Office Action Summary

10/521,914

MAZDA ET AL.

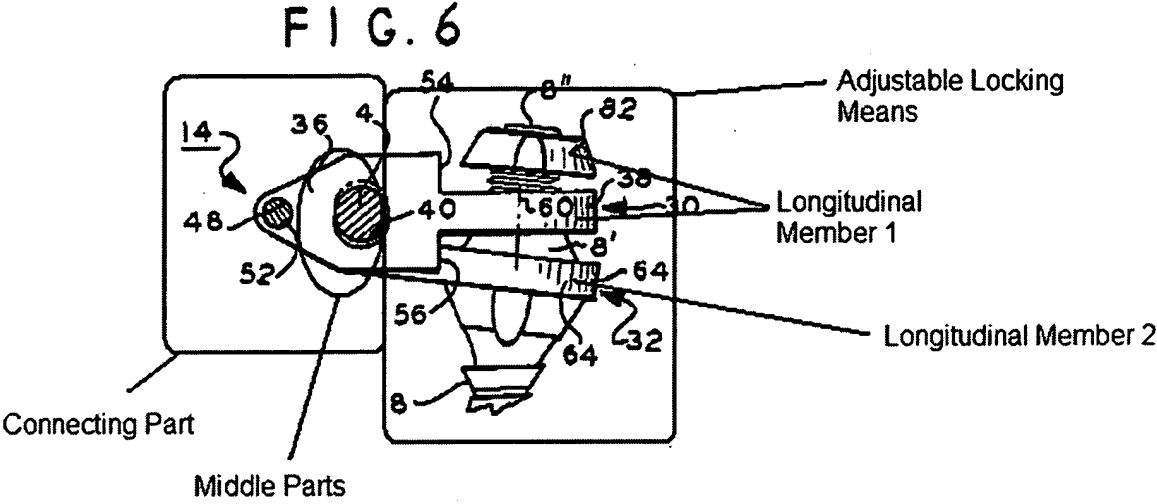
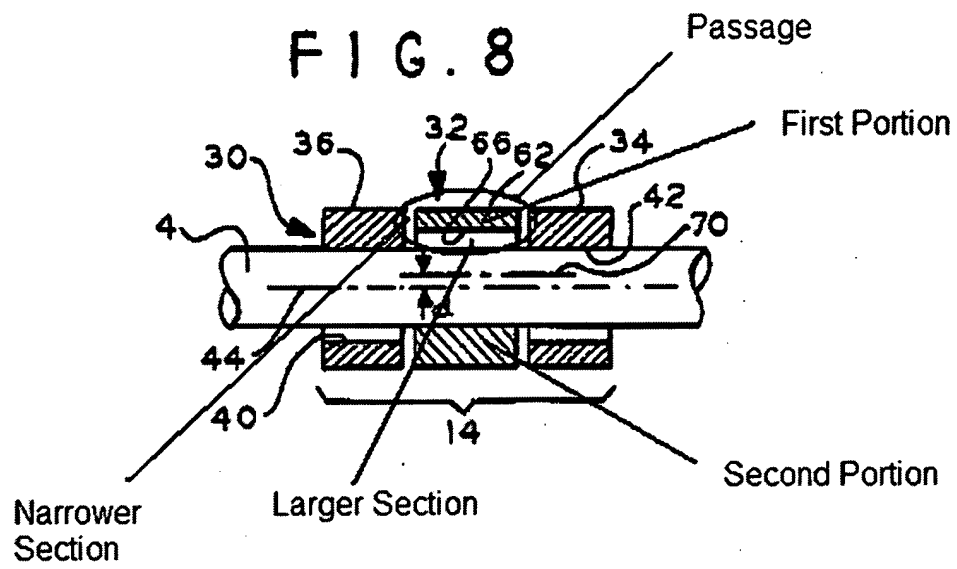
Fiz discloses a vertebral fixing system (Fig. 6 below) that is capable of mounting on a vertebra of the spine to connect it to a rod. The pedicle screw 8 (Fig. 6 below) is capable of mounting the system onto the spine. The system is capable of being placed on the spine in such a way that it would be in the vicinity of a posterior wall of a vertebra. The system comprises a connecting part (Fig. 6 below) capable of facing a rib and/or transverse process and capable of being connected to a rod. Fiz further discloses adjustable locking means (Fig. 6 below) fastened to the connecting part. The connecting part has a passage (as seen in cross section, Fig. 8 below) facing the rod. The adjustable locking means are capable of fixing the rod in place. The connecting part comprises two longitudinal members (Fig. 6 below), whose first ends are connected together and the members may pivot relative to each other. The middle parts (Figs. 6

and 9) of their two facing faces are capable of bearing on respective opposite sides of the rod. The adjustable locking means are capable of driving the second ends of the longitudinal members forcibly towards each other and to fix them in position relative to each other so that the two members form a clamp and grip the rod. This also allows the connecting part to be fixed in position relative to the rod. Fig. 9 further discloses the second ends of the two longitudinal members having a bore in one and a thread in the other, so that a screw may be passed through the bore and screwed into the thread to form the adjustable locking means. The second ends of the longitudinal members have facing each other, a bore in one (Fig. 9 below) and a thread in another. Considering the nut 82 (Fig. 6 below) as part of the longitudinal member, the longitudinal member then has a threaded portion. A screw can then be passed through the bore into the thread and form the adjustable locking means. At least one of the middle parts of the two facing faces has a first portion (Fig. 8) through which the passage passes and a second portion capable of bearing against the rod (Fig. 8). The passage extends between two orifices in the connecting part (Fig. 9 below). The passage is extended between the two orifices, even though it does not span the entire distance between them. The passage has a section that decreases from one orifice to the other (Fig. 8 below), which enables the passage to exert a progressing pressure on the ligature and press it against the rod. The connecting part has a first face (Fig. 6, surface of ref. 32) that can face a rib and/or said process and a second face opposed to said first face (Fig. 6, surface of ref. 30) and being provided with a fastening means.

Fiz does not disclose a flexible ligature having a first end secured to the fastening means, a first portion forming a loop, the first portion facing the first face of the connecting part and a second free end projecting out of the second face.

Burgess et al. disclose a flexible ligature having a first end (Fig. 6, far bottom) secured to the fastening means, a first portion forming a loop (Fig. 6, near ref. numerals 32), the first portion facing the first face of the connecting part (Fig. 6, the portion of ref. 1 that the ligature faces) and a second free end projecting out of the second face (Fig. 6, far bottom), the ligature being used for attaching the vertebral fixing system to the spine (page 2, paragraph 2, lines 1-3).

It would have been obvious to a person having ordinary skill in the art at the time the invention was made to have constructed the vertebral fixing system of Fiz with the ligature attached to the connecting device of Burgess, in order to use the ligament to attach the vertebral fixing device to the spine.
